City of El Paso – City Plan Commission Staff Report

Case No: SUSU14-00008 Mesquite Hills Unit 10
Application Type: Resubdivision Combination
CPC Hearing Date: April 10, 2014
Staff Planner: Alfredo Austin, 915-212-1604, austinaj@elpasotexas.gov
Location: West of Dyer and North of Angora Loop
Acreage: 5.1767 acres
Rep District: 4
Existing Use: Vacant
Existing Zoning: R-5 (Residential)
Proposed Zoning: R-5 (Residential)
Nearest School: Desertaire Elementary (2.46 mile)
Nearest Park: Mesquite Hills #4 (.08 miles)
Park Fees: \$35,620
Impact Fee Area: This property is located in an Impact Fee Service Area and is subject to impact fees.
Property Owner: Direct Home Sales
Applicant: Direct Home Sales
Representative: AB Consultants

The Development Coordinating Committee recommends **denial** of Mesquite Hills Unit 10 on a **Resubdivision Combination** basis until the following comments have been addressed:

ATTACHMENT 3

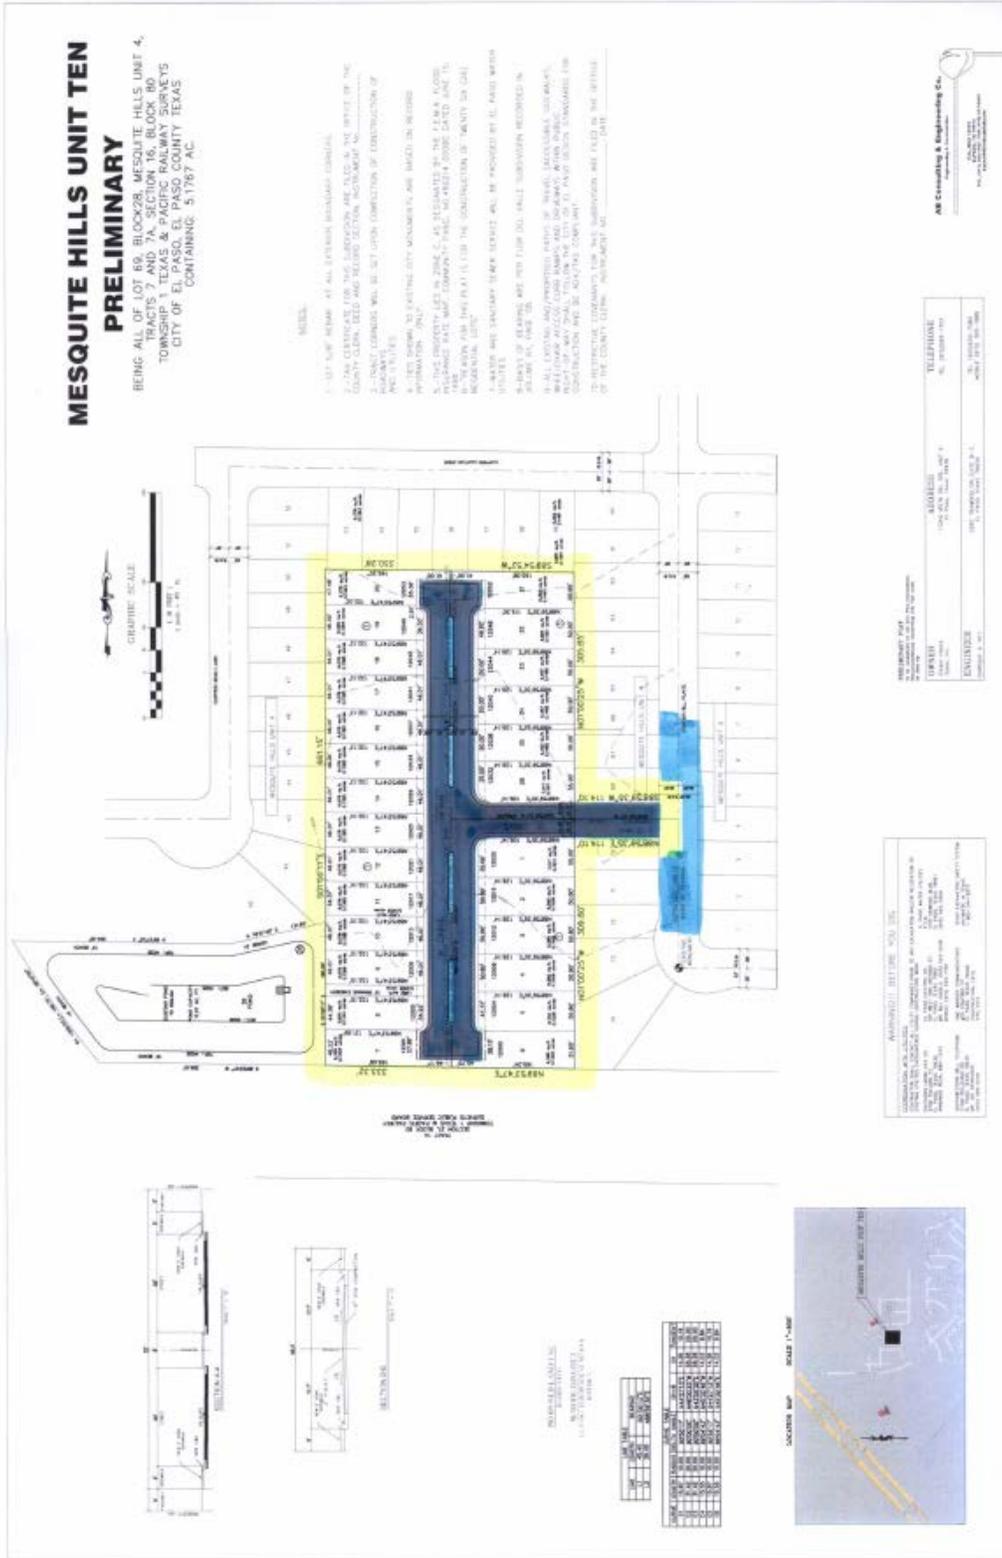
1. Subdivision boundaries need to be properly identified.
2. Under the approval statement, change “City Engineer” to “City Development Director.”
3. Provide cross-sections for “B” Drive, Copper Hill Place and for hammerheads at the end of “A” Drive.

4. Display street names included in subdivision.
5. Cross-section A-A needs to provide for 10’ parkway with 5’ sidewalks.
6. In order to meet the standards set forth in Section 19.15.050 of the current subdivision code, Lot 69, Block 28, Mesquite Hills #4 shall be included in this plat and dedicated as public ROW. Remove “Access Easement per Mesquite Hills Unit 4” wording from plat.

7. Owner of Lot 69, Block 28, Mesquite Hills #4 shall sign off on the replat. Provide proof of ownership.
8. Improvement plans shall be submitted with subdivision application. **Subdivision shall not be deemed complete and will not be accepted without submitted and accepted improvement plans.**

9. Proposed cul-de-sacs do not meet the minimum standards in the subdivision code. A minimum ROW width of 56’ shall be provided, to include 5’ sidewalks abutting the property line and 5’ parkways.

10. Cul-de-sac length exceeds maximum length allowed of 300’ for 52’ ROWs, therefore a 56’ ROW width is required for the cul-de-sacs.
11. Proposed hammerhead design does not comply with standards set forth in Section 3-17 of the Design Standards for Construction (DSC). Hammerhead design shall meet all minimum standards as shown in Section 3-17 of the DSC.

12. Staff proposes 20’ of pavement with 5’ parkways and 5’ sidewalks abutting the property line for portion of ROW connecting to Copper Hill Place. This cross-section would be in line with the 40’ residential lane cross-section in the current subdivision code.

13. Include square footage of each lot on preliminary and final plat.
14. This property is subject to impact fees. The table and respective language shall be included on the face of the final approved and recorded plat.

15. Provide correct block numbers.
16. Provide 8.5x11 copies of plat.

1. Subdivision boundary lines need to be solid phantom (double dashed lines).
2. Individual lot lines need to be solid lines.
3. Provide City monument at intersection of proposed roads.
4. Verify cross Section A-A sidewalk label and dimensions coincide.

5. Add to general notes on final plat: “The retention of the difference between Historic and Developed Storm-water runoff discharge volumes shall be retained within subdivision limits (DSC, 19.19.010A (DDM, 11.1)). Historic storm water runoff rates must not be exceeded.”

1. **EPWU requires for the access easement (Lot 69, Mesquite Hills Unit 4, Block 28) to be dedicated as a public right-of-way to allow for the installation of public water and sewer main extensions to serve the subject subdivision. Water and sanitary sewer mains will not be allowed to be constructed within the access easement.**

2. Sanitary sewer is critical for the southern portion of the subdivision. The Owner must grade the property to allow sewer service by gravity to the existing sewer main along Copper Hill Place.

Please correct block numbers.

The El Paso County District requests that street names be displayed in **MESQUITE HILLS UNIT TEN SUBDIVISION PLAT.**
